CITY PLAN COMMISSION STAFF REPORT

Maple Woods Mixed Use

CD-CPC-2024-00100 Rezoning CD-CPC-2024-00101 Development Plan

Report Date: August 29, 2024 Case Number: CD-CPC-2024-00101 Project: Maple Woods Mixed Use

SITE PLAN

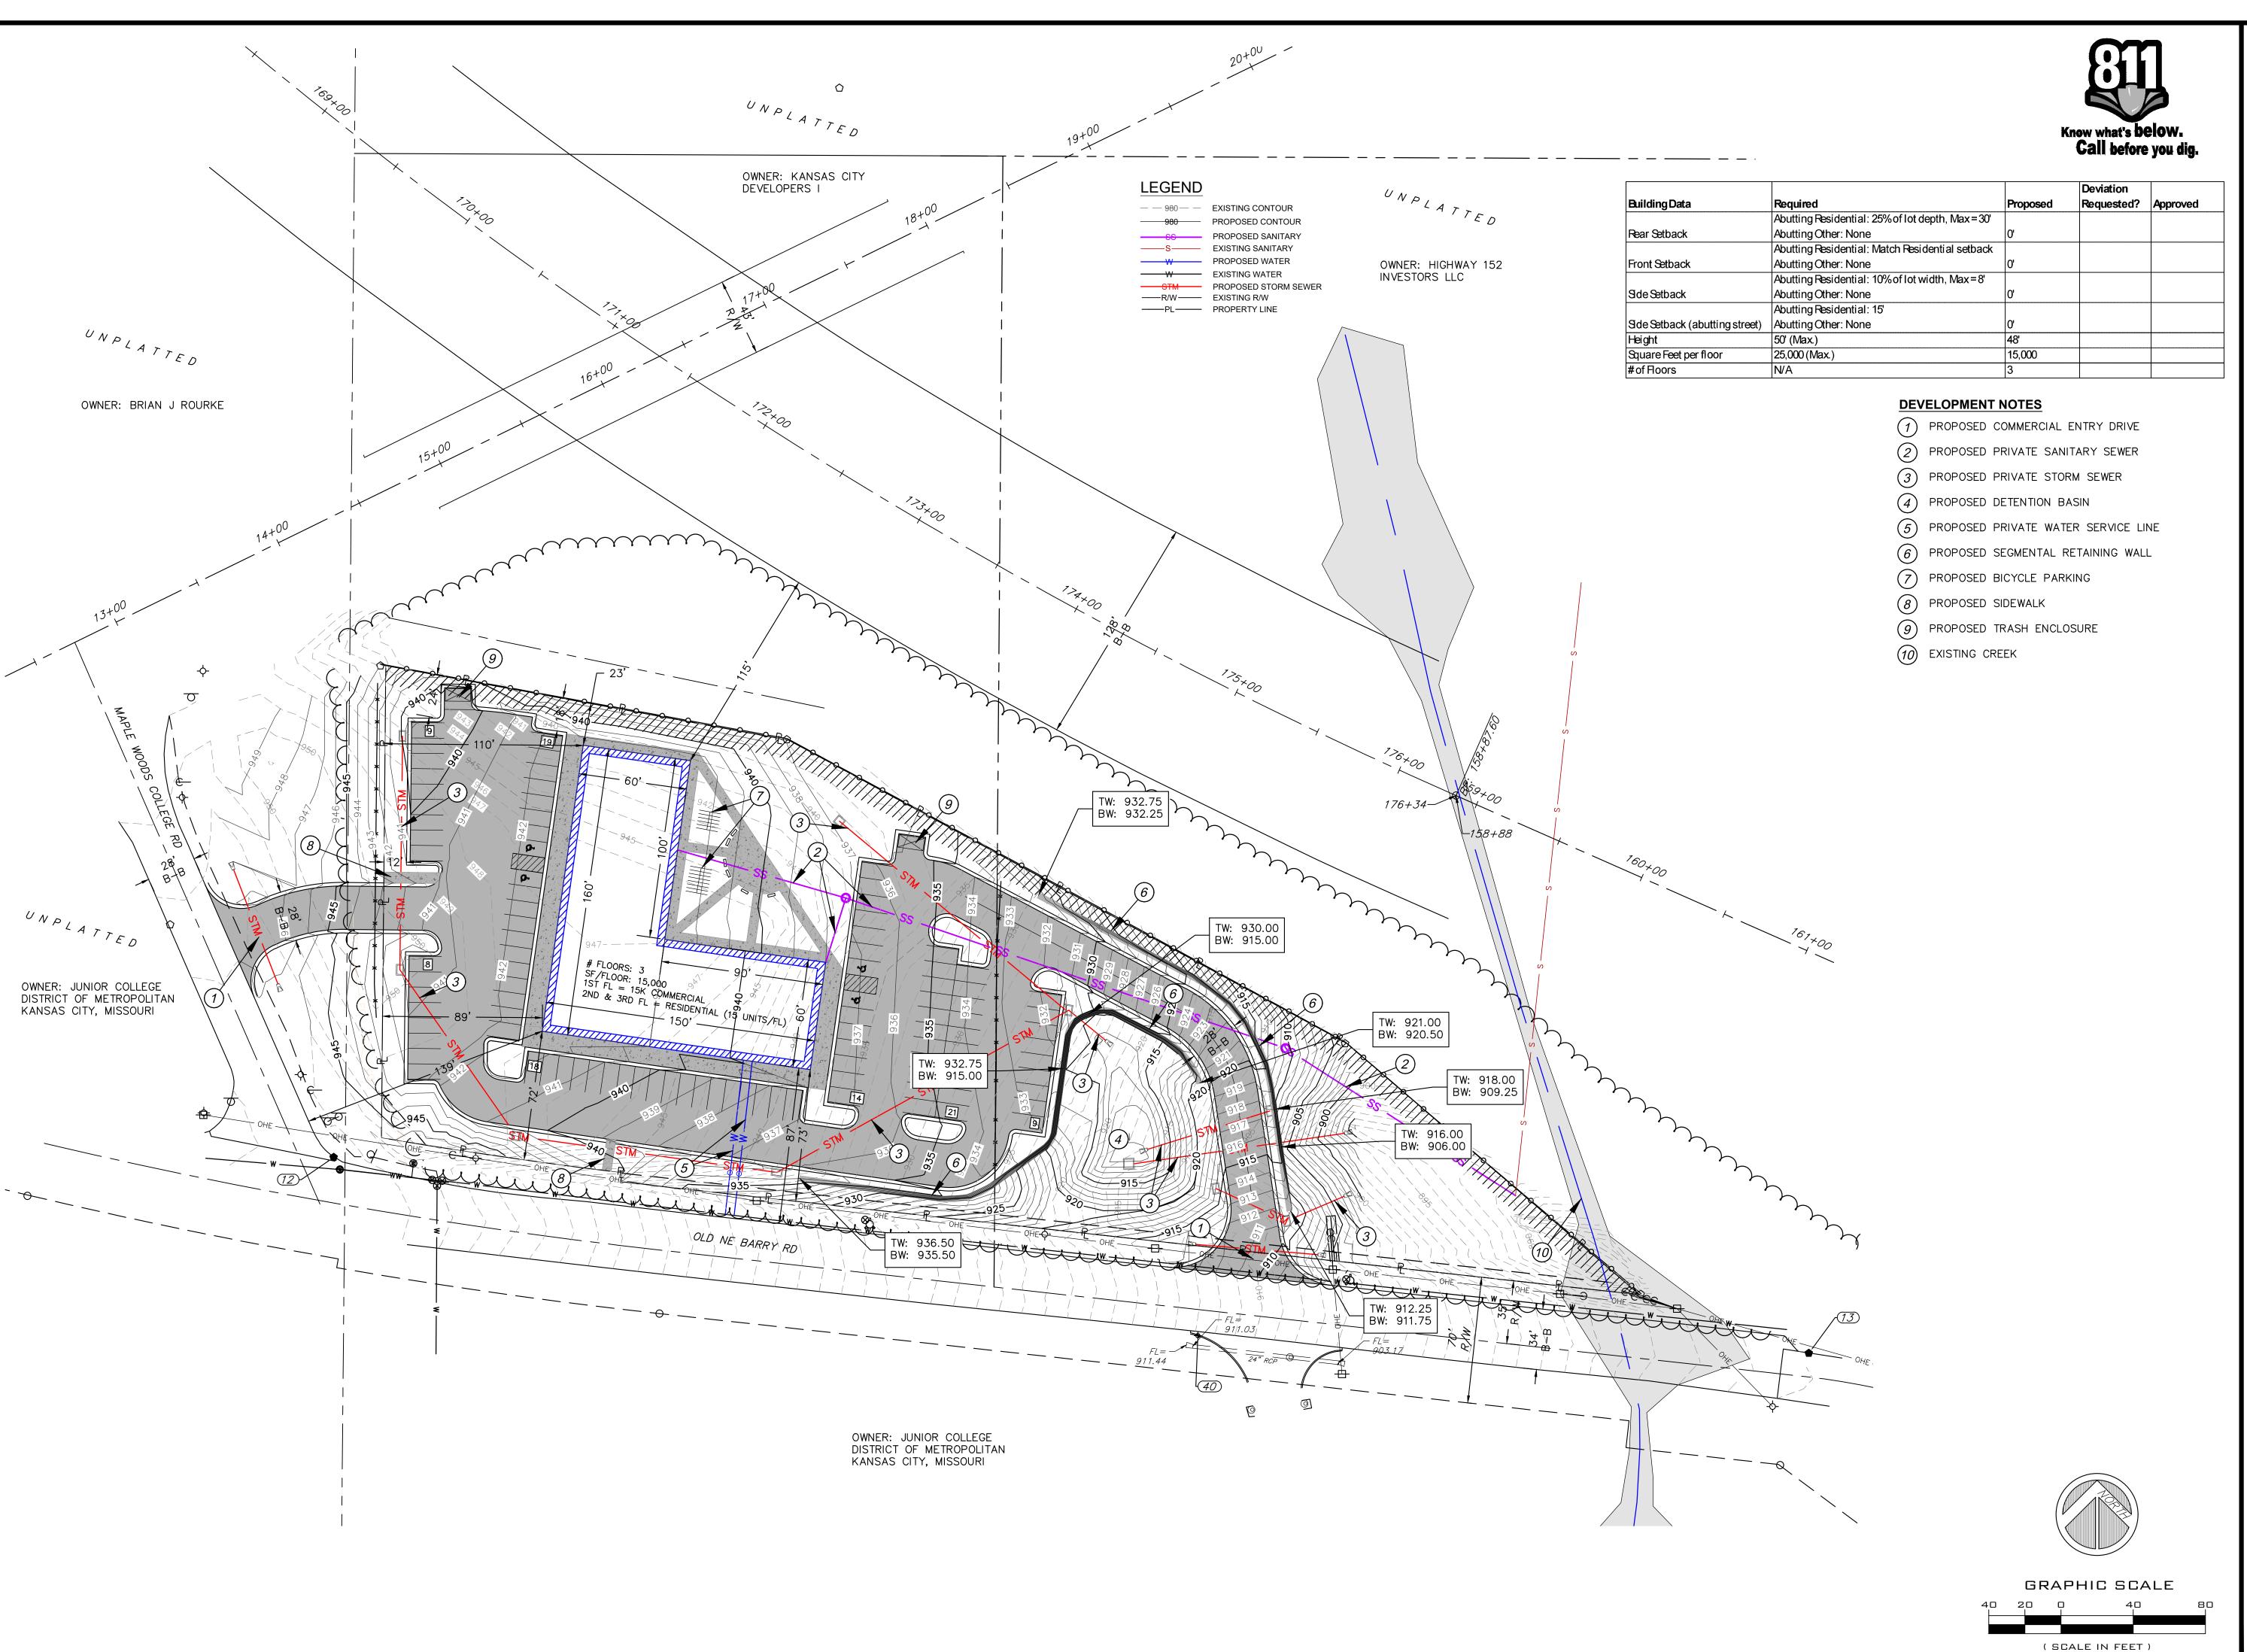
- 1. In the building data table on sheet C-1, list all proposed setbacks based on the proposed building and vehicular use areas. UPDATE 8/21/24: No changes made to the proposed setbacks on the Building Data table. The drawing is not showing setbacks of 0 ft. (8/16/2024)
- 2. Show all plantings/quantities on the drawing. UPDATE 8/21/24: Vehicular use area must be screened with a continuous evergreen shrubs along the south side of the site. The continuous shrub line must be shown on the plan. (8/16/2024)

EXISTING CONDITIONS
TREE PLAN/
TREE PRESERVATION
& MITIGATION PLAN

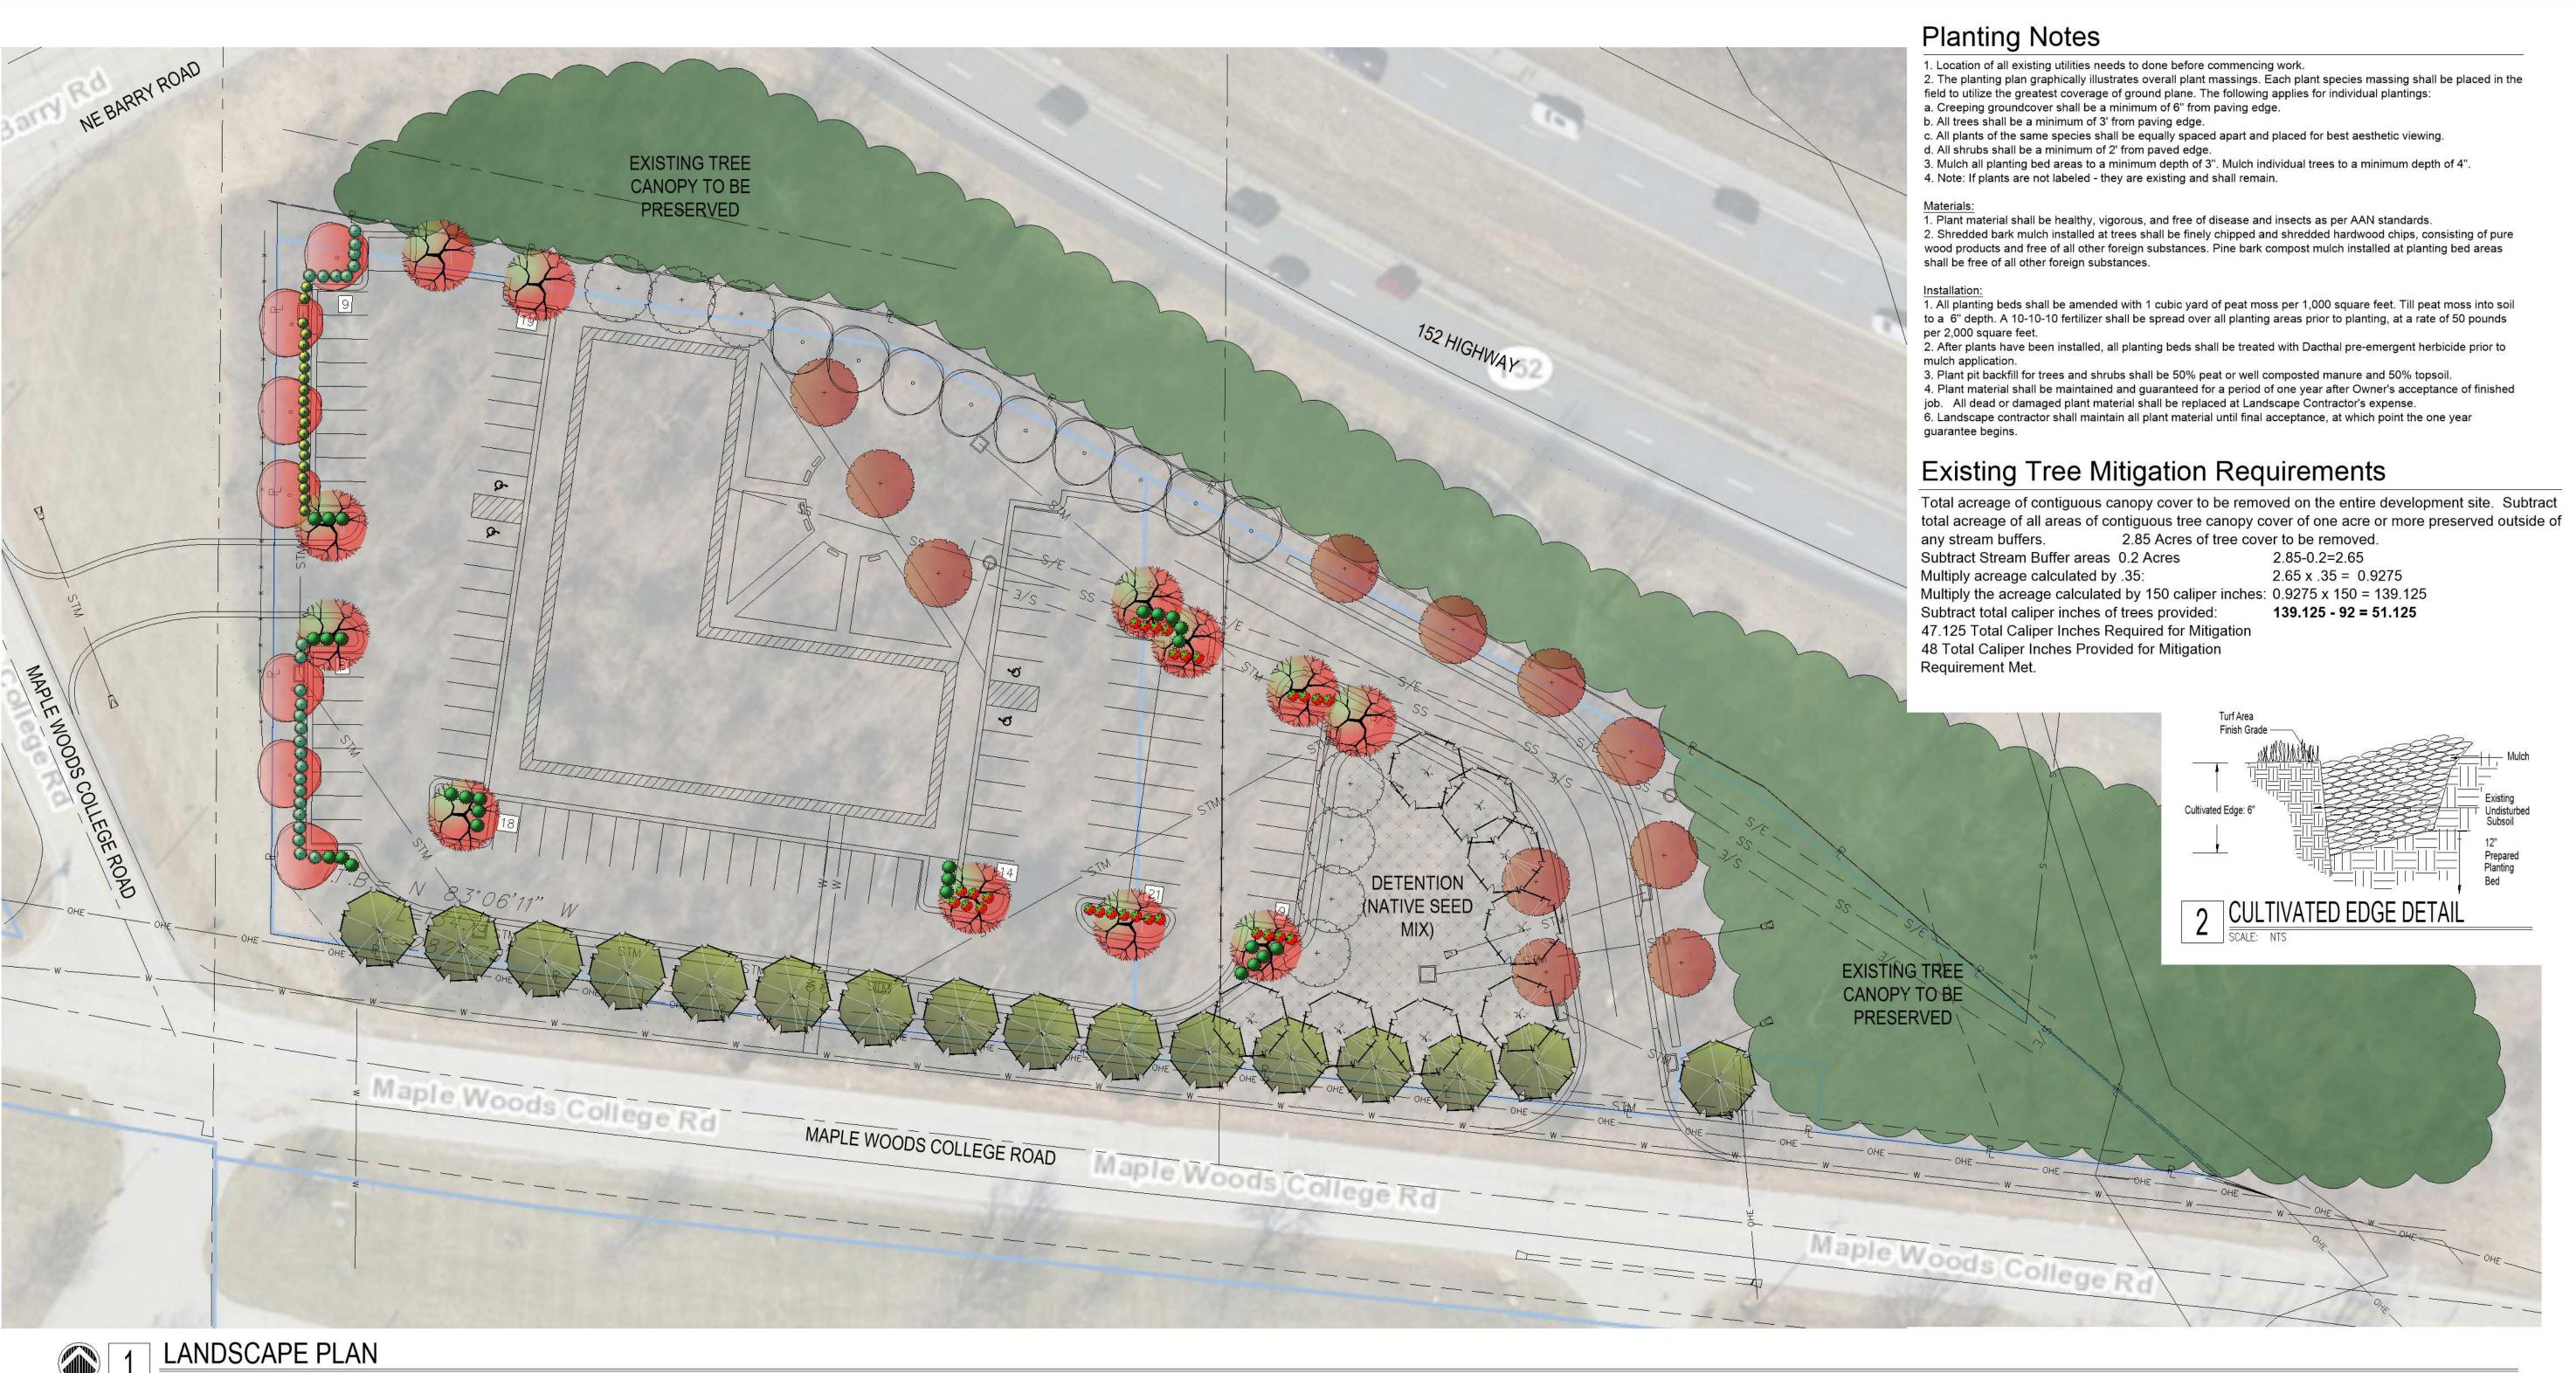
There is a tree preservation and mitigation plan associated with this application that complies with Code. The plan drawing shows areas of existing tree canopy to be preserved; however, these areas are within City and MODOT right of way, which the applicant does not have jurisdiction to remove. Only 0.2 acres of tree canopy will be preserved within the stream buffer, which is required by 88-415 – Stream Buffers.
